Hi-Fi Products  
**Service Bulletin**

**Model:** TC-818M, MHC-3300CD

**No.** 321

**Subject:** Clicking Noise

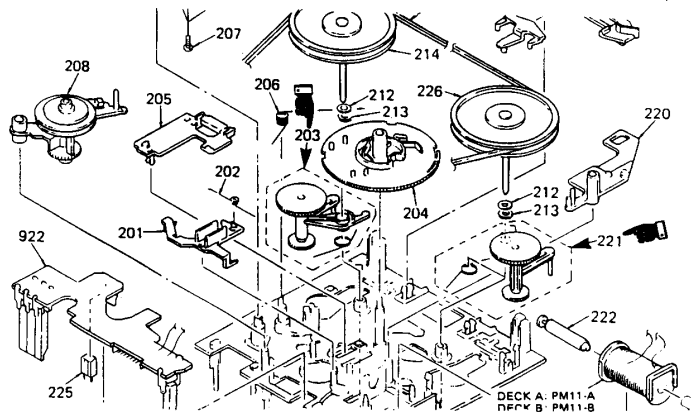
**Symptom:**  
(64) Clicking noise in either A or B Decks.

**Solution:** Please change the following parts with the improved versions. (same part numbers).

REF	DESCRIPTION	PART NUMBER
203	LEVER (TU ARM REV) ASSY	X-3343-406-1
221	LEVER (TU ARM FWD) ASSY	X-3343-405-1
